April 2, 2021

Attn: City Council, City of Clayton

RE: Proposed Oak Creek Canyon Drive - Illegal Nonconformance MCRSP

■ ■ ■
FIGURE 6

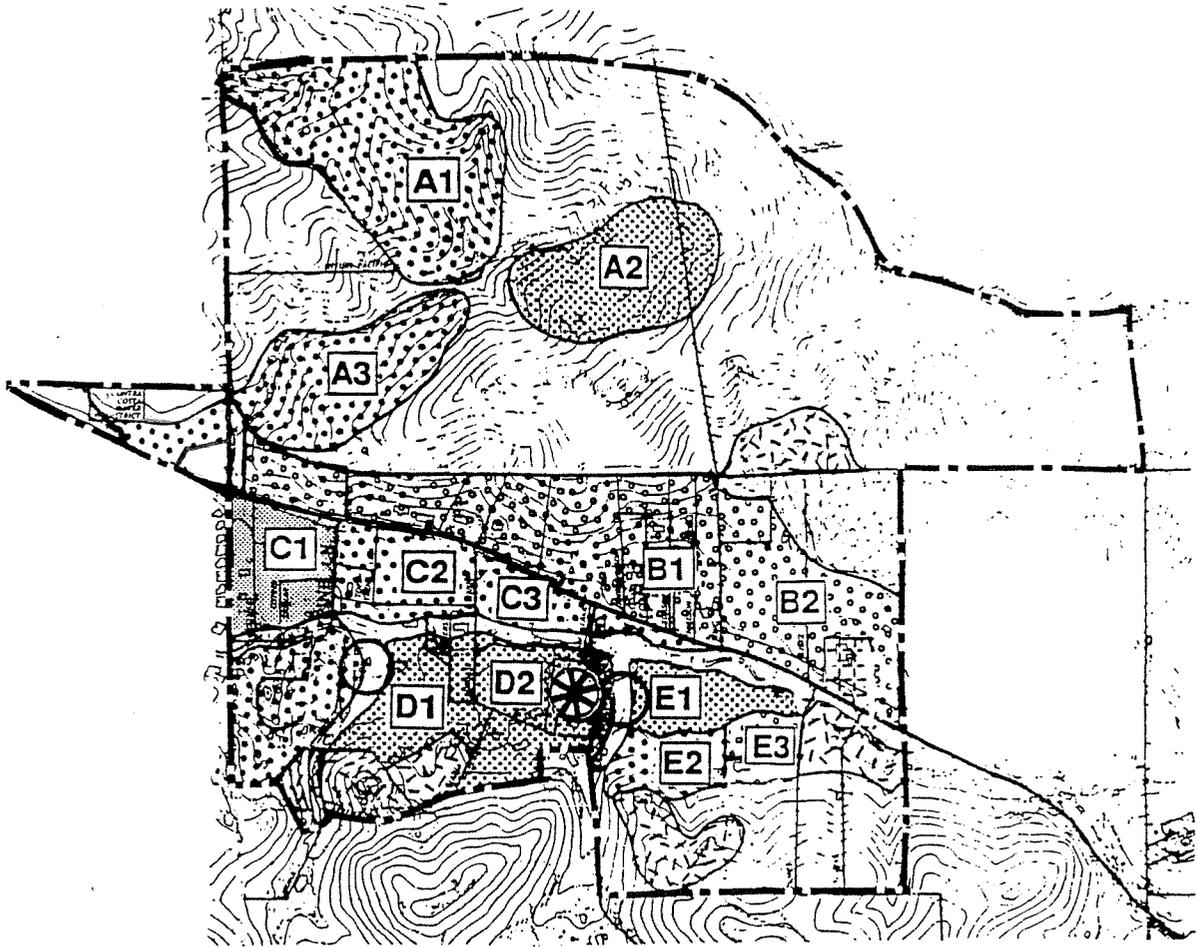
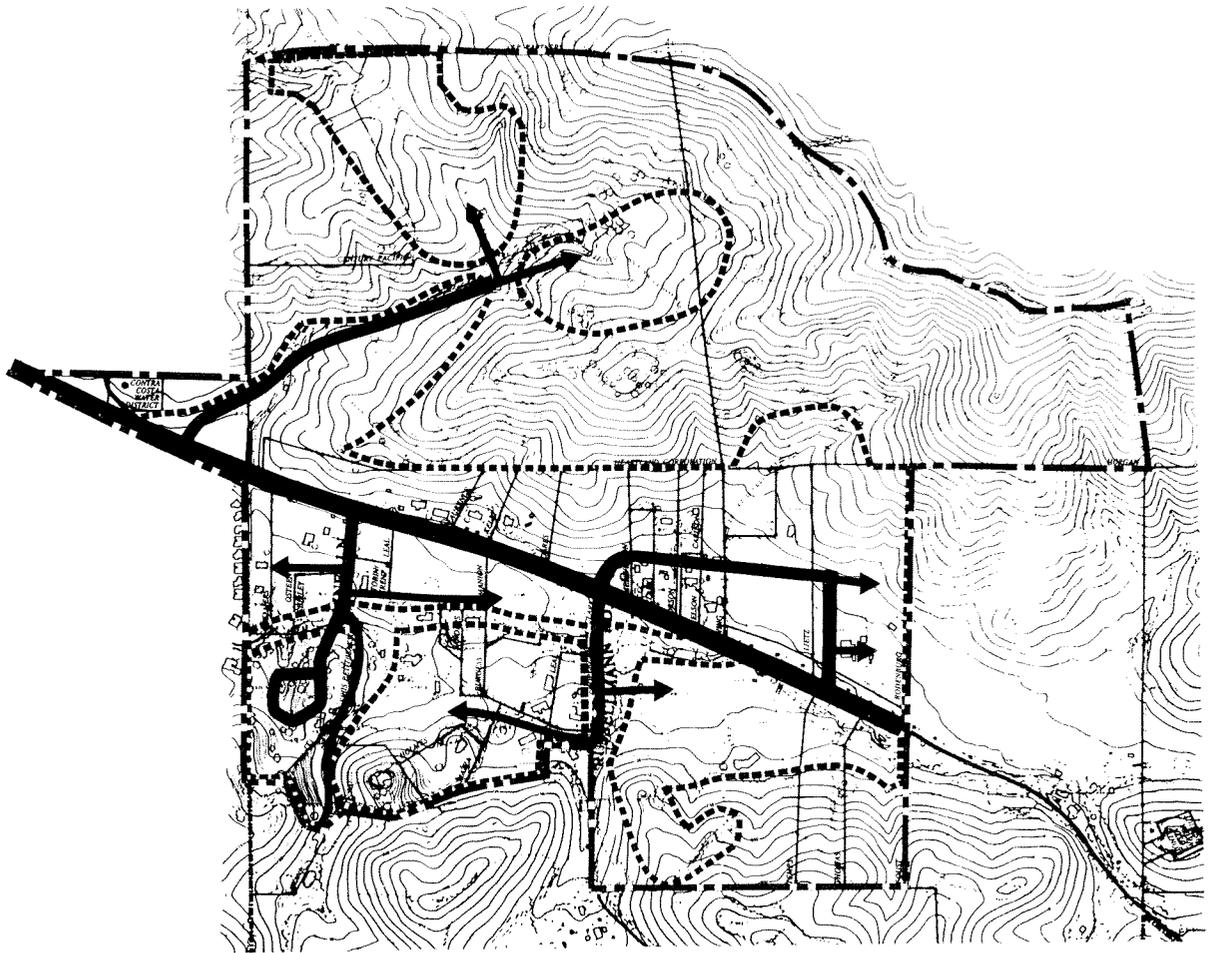
I represent the interests of Clayton Estates, LLC: owner of the majority of the developable land in Section A of the Marsh Creek Road Specific Plan's land use designation. The property amounts to over 160 acres and was planned for over 110 homes, after over 42 public meetings in 1995. *See* Exhibit 4, Figure 6.

FIGURE 10

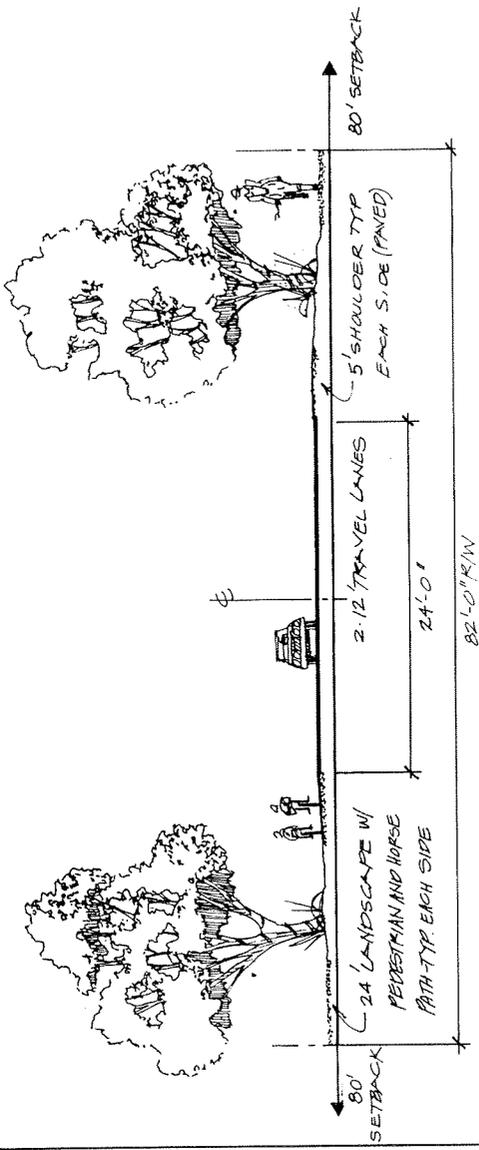
The MCRSP provides that the road to be constructed on the subject site must be a Collector Road. Per the MCRSP, a Collector Road must have a 48' right-of-way with 32' of pavement to provide sufficient access to the Moita, Heartland, and Morgan interests. *See* MCRSP Figure 10, attached in Exhibit 4.

Seeno’s proposed tentative map is not consistent with this standard. Moreover, Seeno has not made a request to alter the specific plan to overcome such inconsistency. Seeno argues that following the MCRSP would require them to build a “road to nowhere.” So be it; the MCRSP makes no exception for first-moving developers to curtail infrastructure improvements so as to only serve their own parcels. We contend the collector road is not a road to nowhere, but, even if so, the MCRSP requires developers to conform to the standards set forth therein and then, potentially, seek funding via reimbursement or alternative funding mechanisms as contemplated by the plan.

To do so, the Conditions of Approval Modifications No. 2, No. 3, and Street Conditions No. 1. must be modified to match the Circulation Element CI-2b, which among other requirements, demand buildout of 32-foot-wide pavement. Draft language is provided in Exhibit 2, showing both current language and acceptable proposed modifications for conformance with the MCRSP.

FIGURE 13

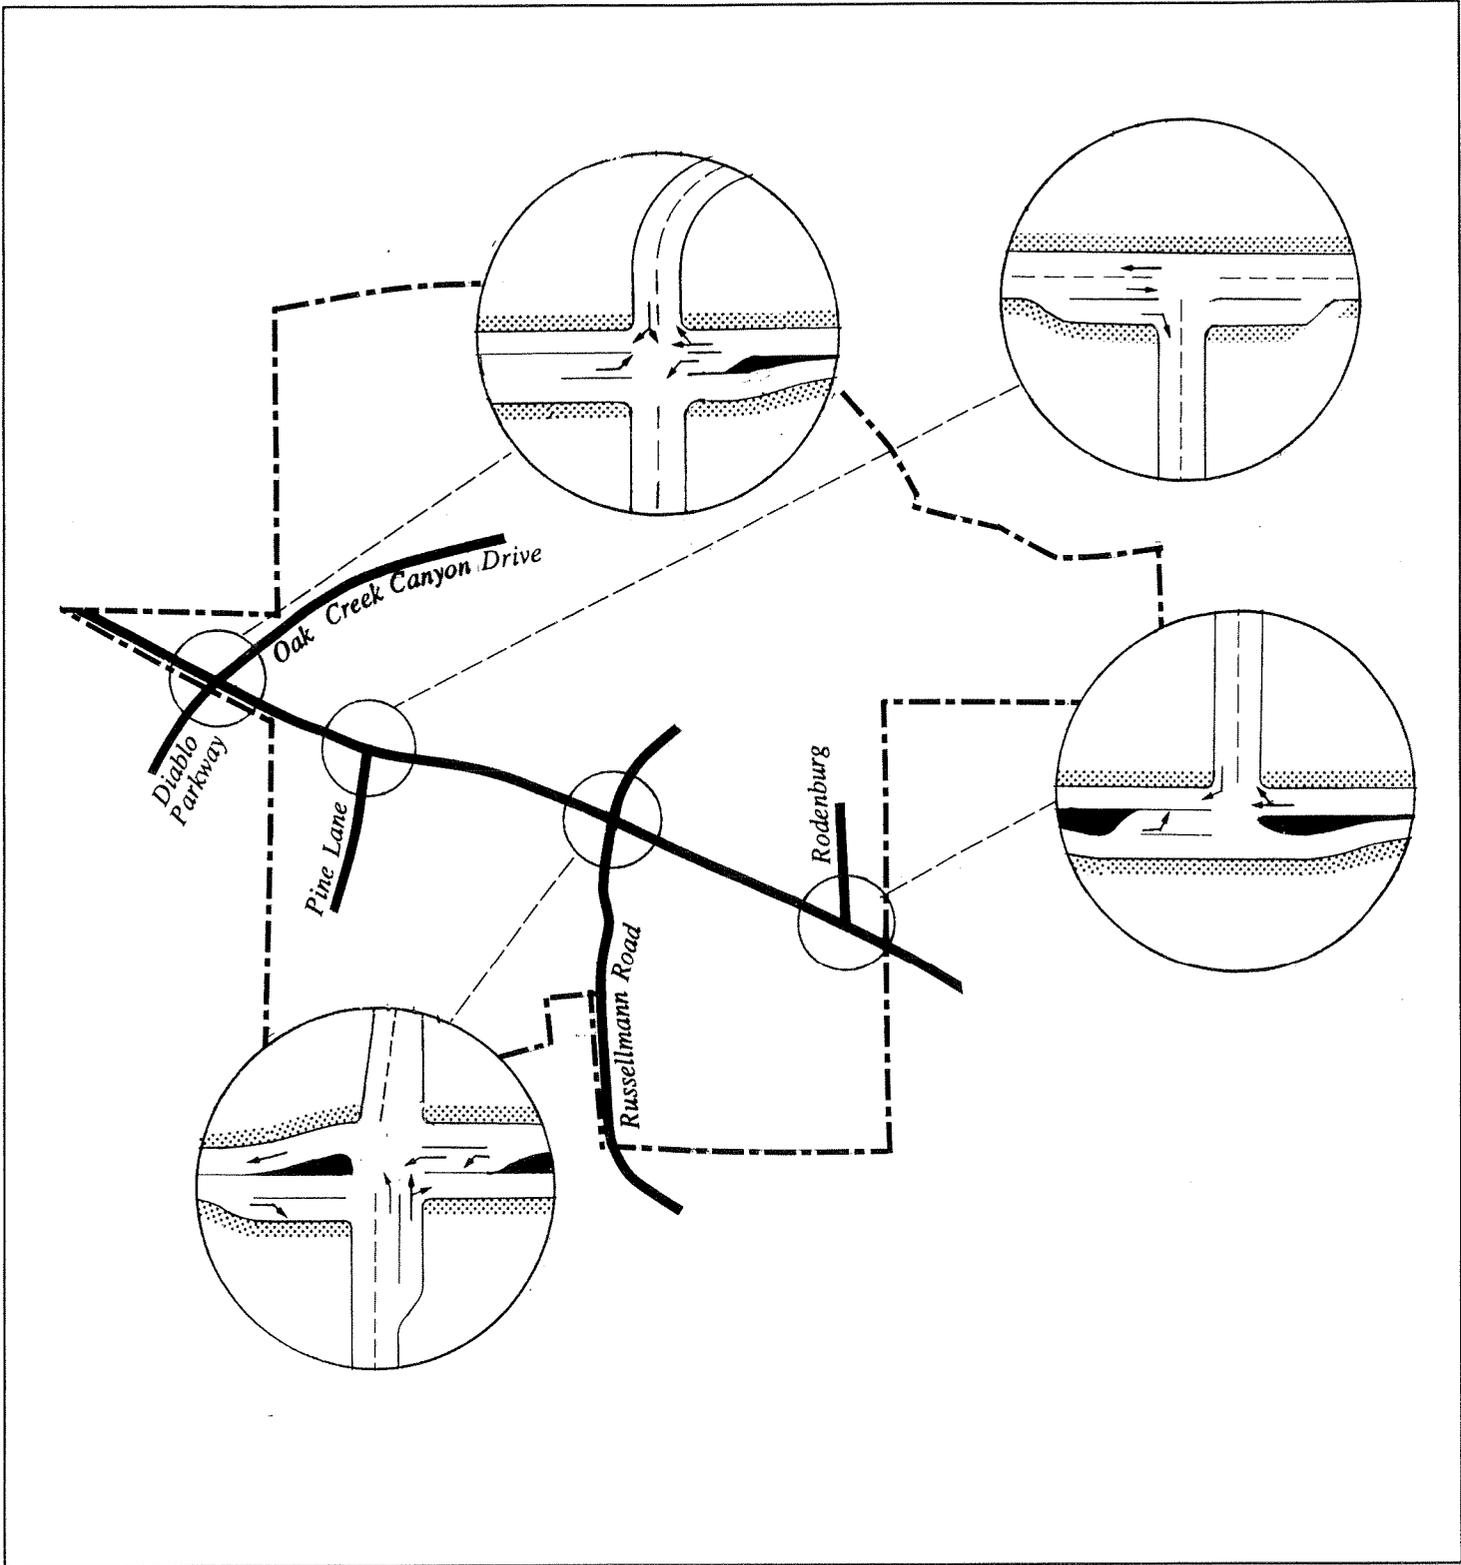
As a final point, we contend the name of the proposed road should remain Oak Creek Canyon Drive, not Saltbush Lane. The name Oak Creek Canyon Drive is consistent with City Council Resolution No. 68-2003 and extensively documented in the MCRSP. *See* Figure 13, attached in Exhibit 4.
